<b>Docket Number:</b>	23-OPT-02
<b>Project Title:</b>	Darden Clean Energy Project
<b>TN #:</b>	259510
<b>Document Title:</b>	Updated Darden Clean Energy Project Description_Redline
<b>Description:</b>	An updated Project Description reflecting the removal of the green hydrogen component and addition of information provided in the Data Request Response Sets. Revisions are shown in redline.
<b>Filer:</b>	Evelyn Langsdale
<b>Organization:</b>	Rincon Consultants
<b>Submitter Role:</b>	Applicant Consultant
<b>Submission Date:</b>	10/9/2024 3:15:35 PM
<b>Docketed Date:</b>	10/9/2024

## 2 Project Description

**Figure 2-2 Project Site and Components**

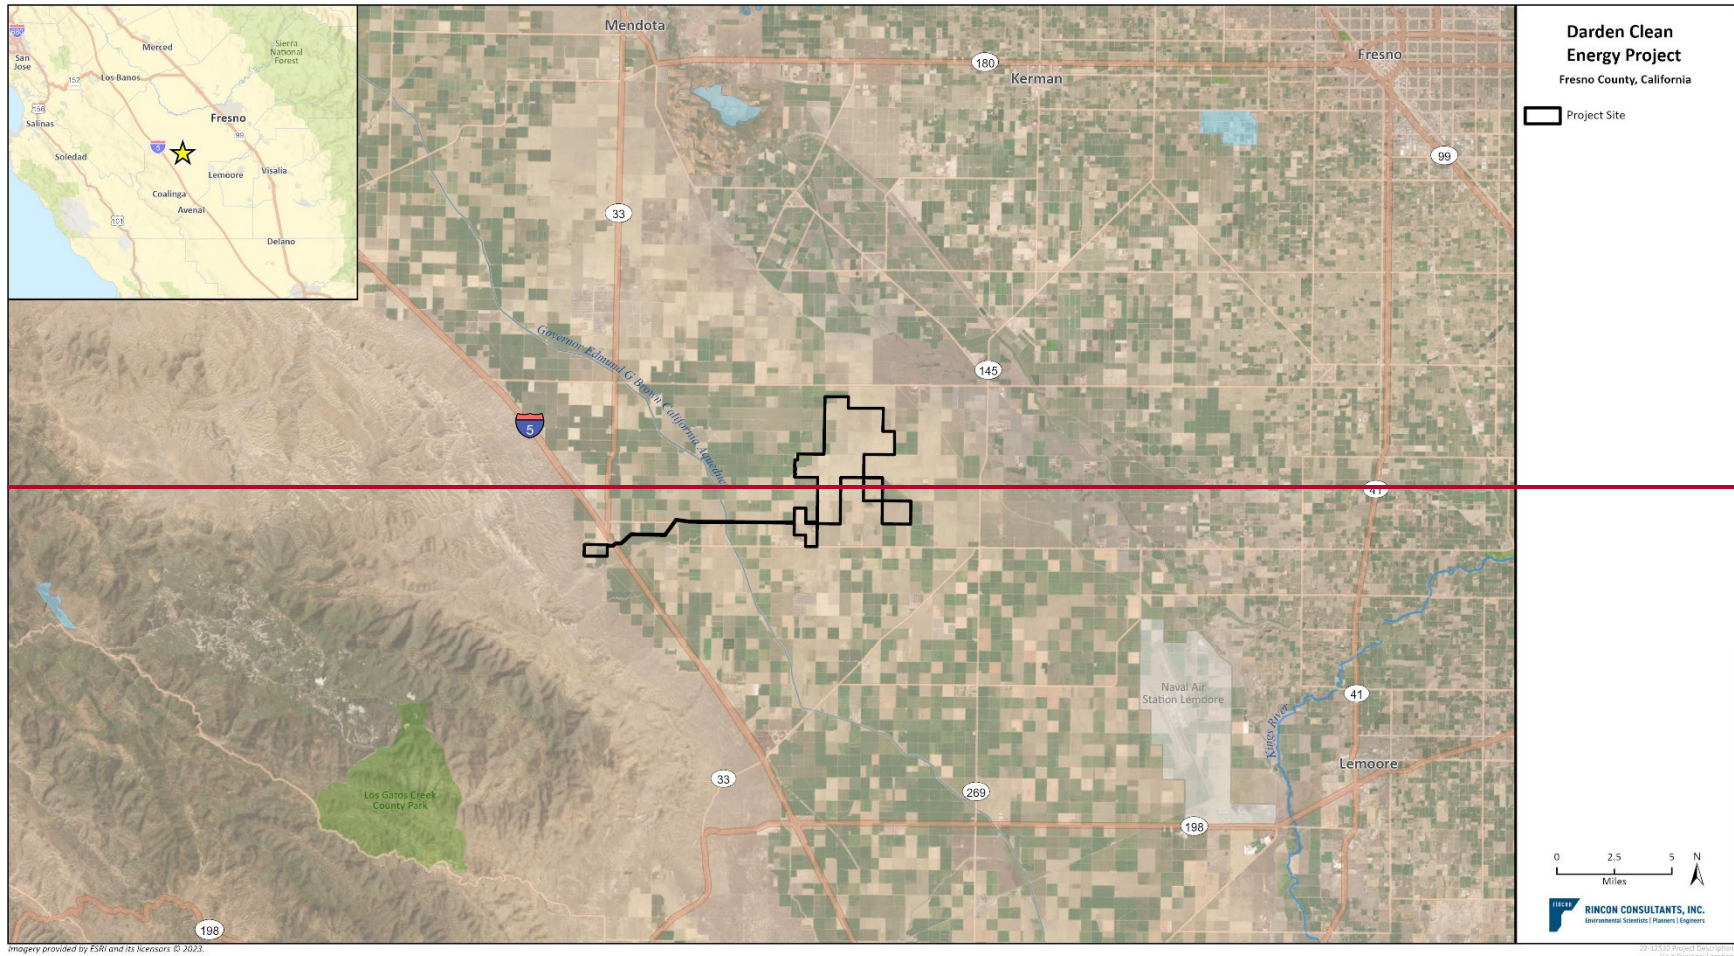
Figure 2-2 shows the Project site plan and location of the solar facility ~~and~~, BESS, ~~and green hydrogen facility~~, as well as the step-up substation, gen-tie line, and utility switchyard, which are discussed in Section 2.2. The gen-tie line would extend from the solar facility west to the proposed utility switchyard along PG&E's Los Banos-Midway #2 500 kV transmission line. As shown on Figure 2-2, two locations (Option 1 and 2 sites) are being considered for the BESS, ~~hydrogen facility~~, and step-up substation. If the Option 1 sites are selected, the gen-tie line would be extended for approximately four miles to connect from the western edge of the solar facility to the Option 1 project components. ~~In addition, an alternate site is being considered for the hydrogen facility, located west of Interstate 5 and adjacent to the proposed utility switchyard site. If the alternate site is selected, it would include the construction of an additional substation and switchyard. If the alternate site is not selected, the Project would not develop the parcels beyond construction of the gen-tie line.~~ The Executive Summary includes a mapbook that shows the Project parcels, section, township, and range, as well as the proposed locations of the Project components. Appendix A contains a list of property owners. Section 5.5, *Visual Resources*, includes photo simulations of the Project. In addition, Appendix F contains scale plan and elevation drawings depicting the relative size and location of all facilities that were used to create Project visual simulations.

- Three locations are being considered for the green hydrogen facility. The Option 1 and Option 2 sites would be approximately 225 acres in size and would be located within the solar facility. The green hydrogen facility at either of the Option 1 and Option 2 sites would generate up to 1,150,800 MW of green hydrogen. In addition, an approximately 100-acre alternate site located west of Interstate 5 and adjacent to the proposed utility switchyard site is being considered. If the alternate site is selected, it would generate 800 to 1,000 MW and include the construction of an O&M building within the facility boundaries, as well as a substation and switchyard on approximately 20 additional acres adjacent to the facility (Figure 2-2).

~~If the alternate green hydrogen facility site is selected, the Project would include construction and operation of a dedicated green hydrogen substation. This substation would be located on approximately 15 acres adjacent to the alternate green hydrogen facility on the west side of the Project site (Figure 2-2).~~

~~If the alternate green hydrogen site is selected, the Project would also include construction and operation of a green hydrogen switchyard on approximately 5 acres on the west side of the Project site (Figure 2-2). The alternate green hydrogen switchyard would consist of up to three 500 kV circuit breakers, associated high voltage switches, and steel structures, including A-frames, which would be up to 120 feet in height.~~
